Operability Analysis of Purge and Vent Valves

"Nine Mile Point"

SUBJECT: Torque Analysis of Purge & Vent Valves

REFERENCE: Docket 50-220 September 21, 1983 Correspondence  
NRC Comments Regarding the Previously Submitted  
Allis-Chalmers Operability Analysis

Figure V-2

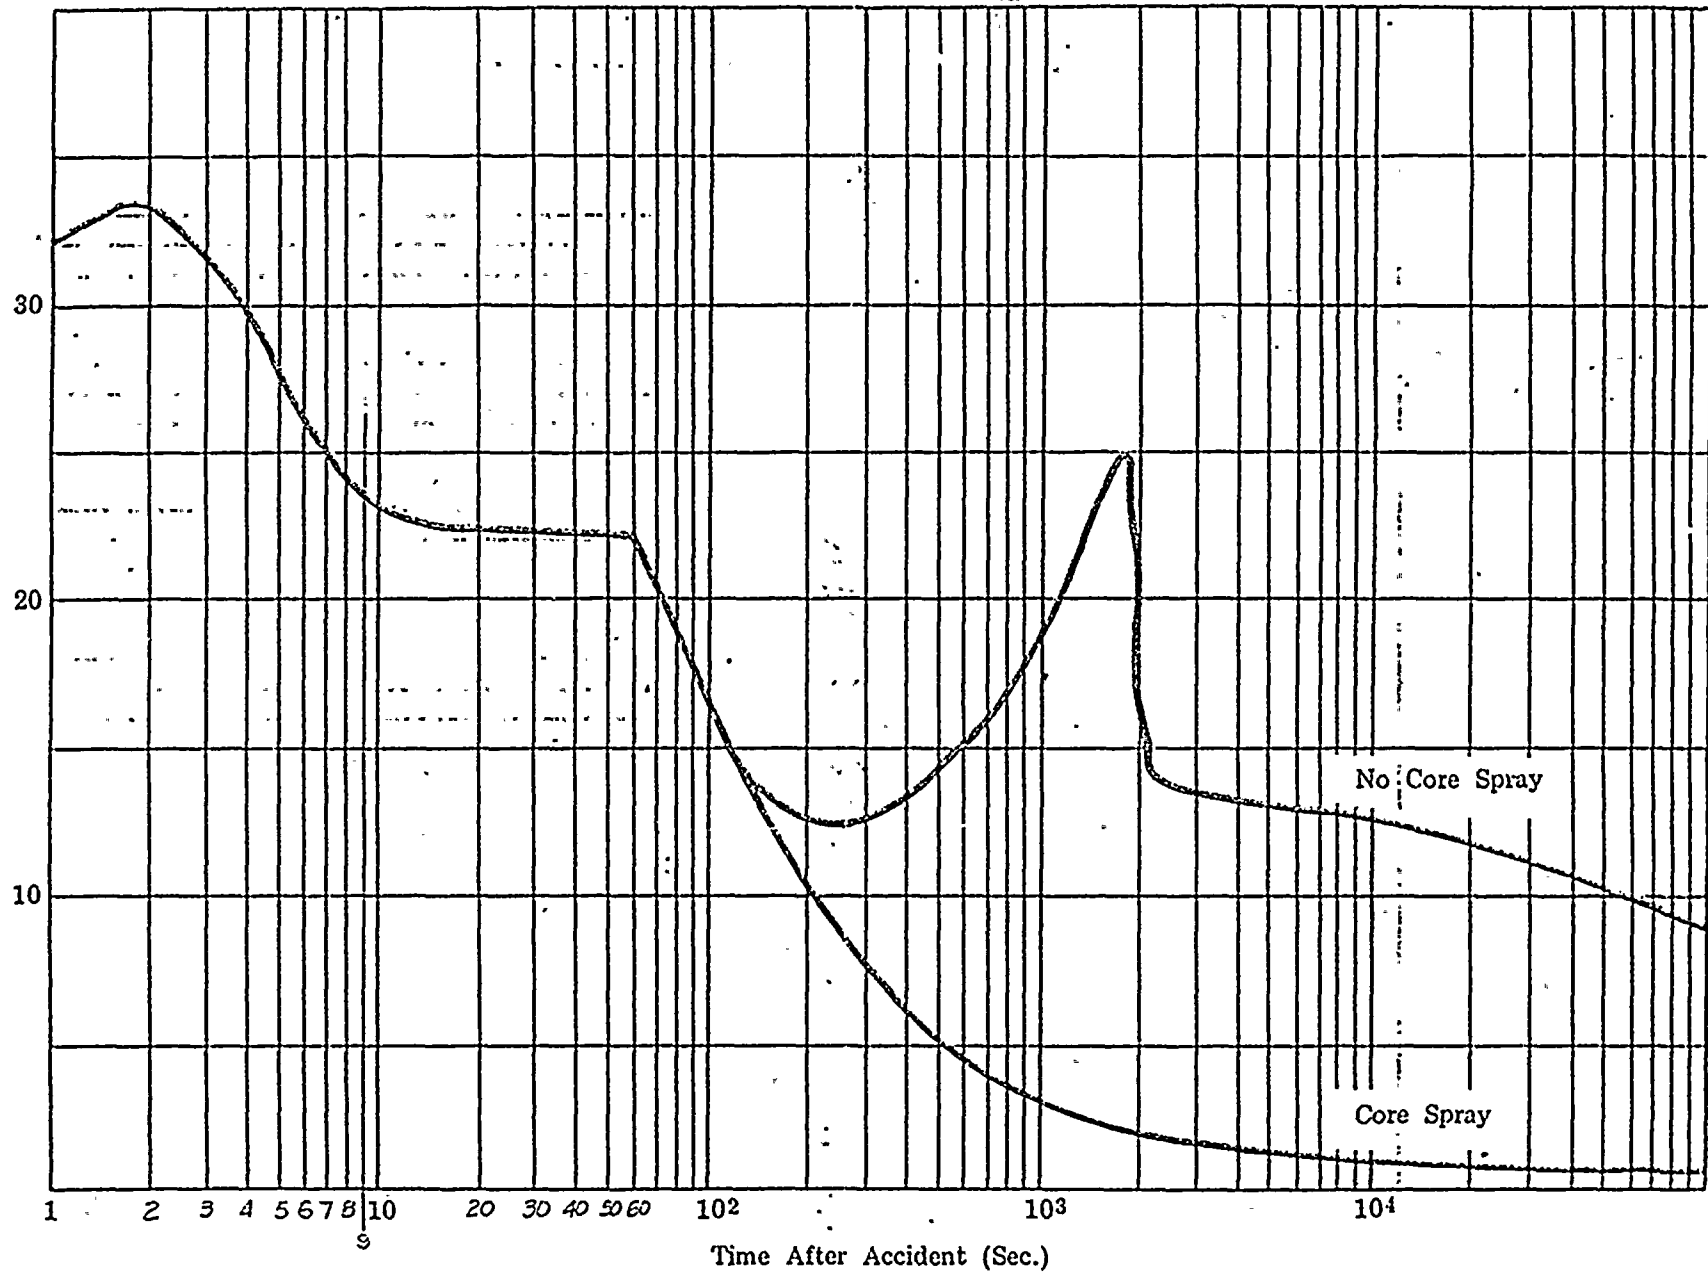
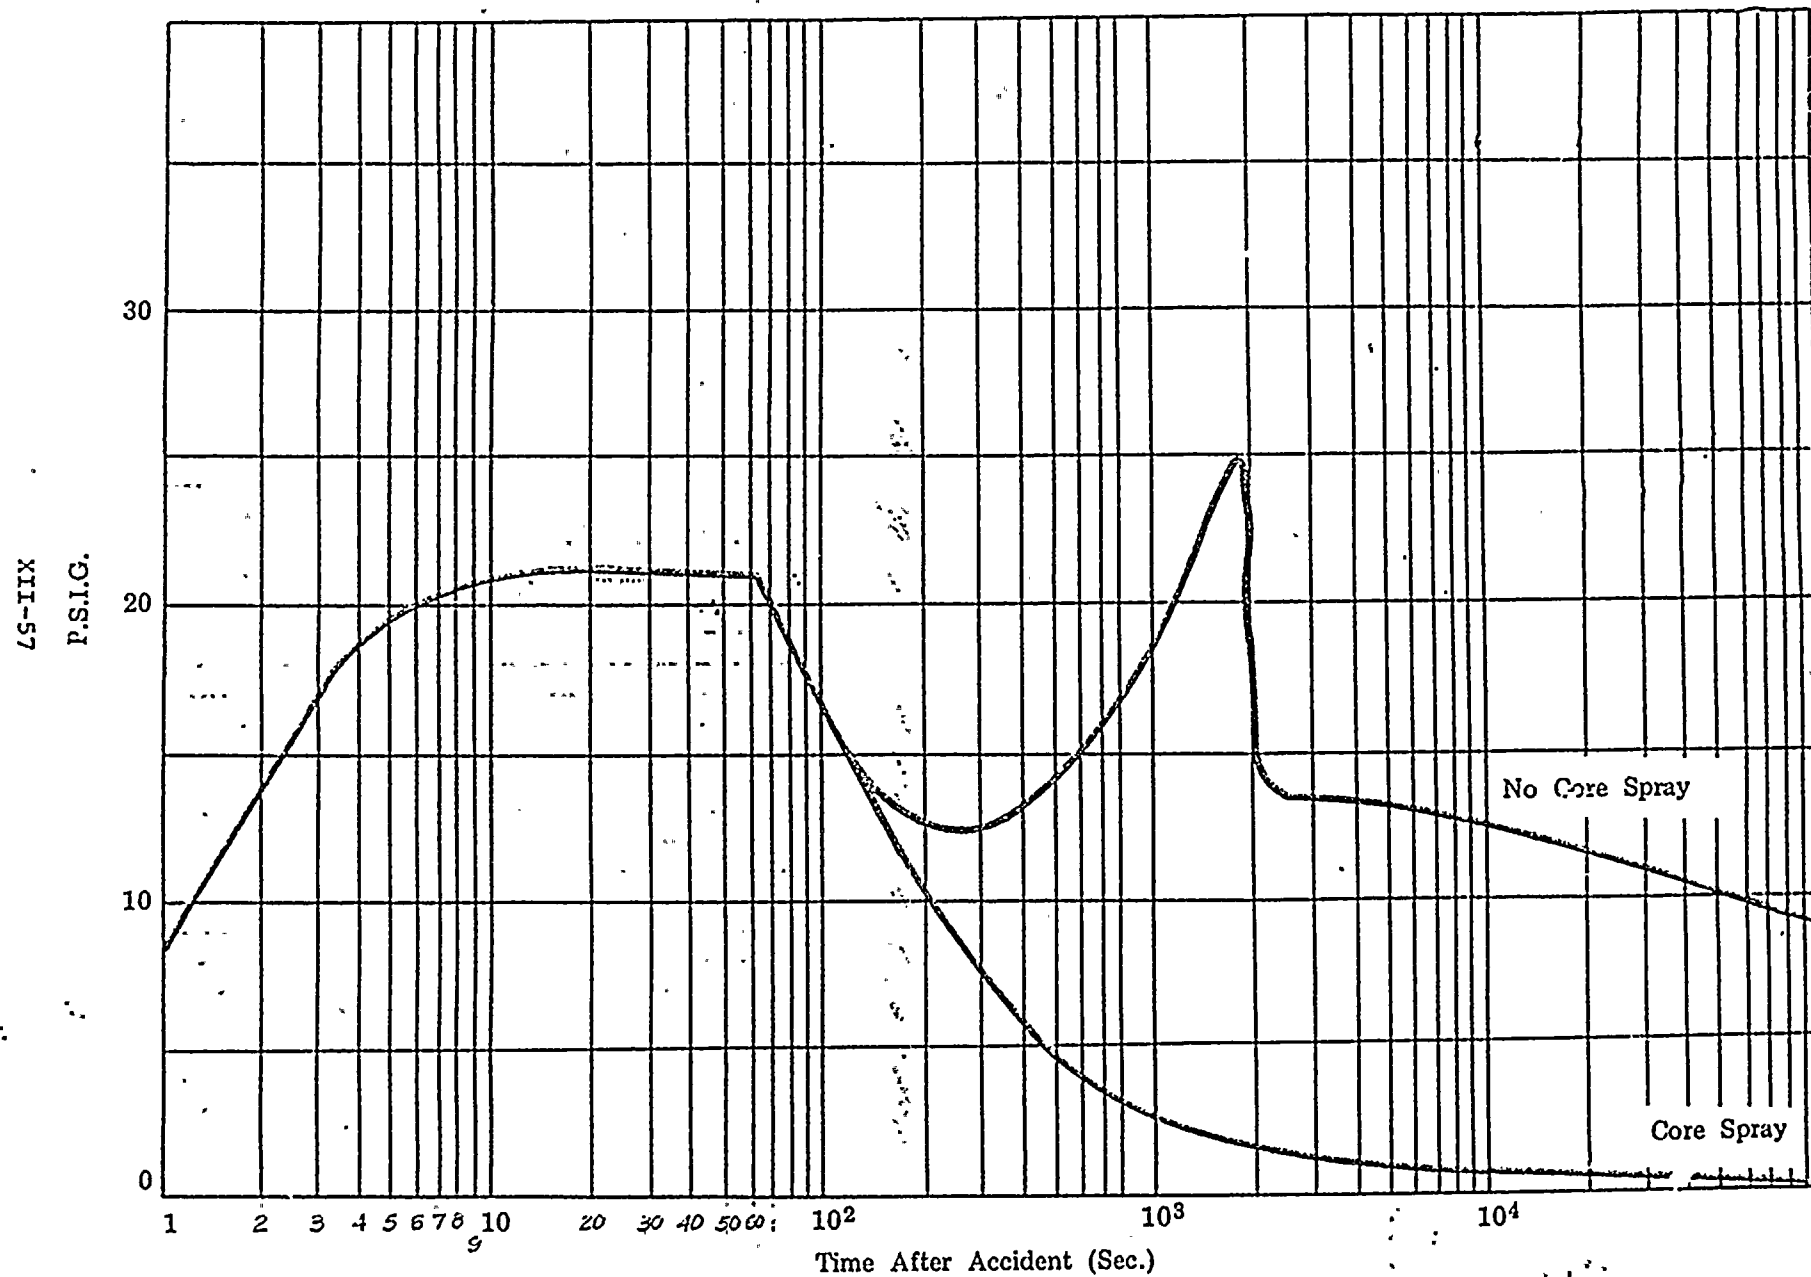
- 4.1 This is correct, all torque analyses have been corrected  
to show the bearing torque as negative and additive to  
dynamic torque.
- 4.3 The analyses were modified to reflect different ramp  
curves for drywell and suppression chamber locations.  
In addition, all valves were analyzed based upon  
closing in 0, 1 and 3 seconds delay from the 50°  
position.

1. New ramp curves for suppression chamber and drywell  
(copies attached)
2. Valve operating = 30 seconds
3. 0, 1 and 3 second delay respectively before valve  
disc movement
4. Valve orientation and upstream piping as indicated  
by confirming site inspection, verified by Rich Neild
5. All valves are blocked at 50° open
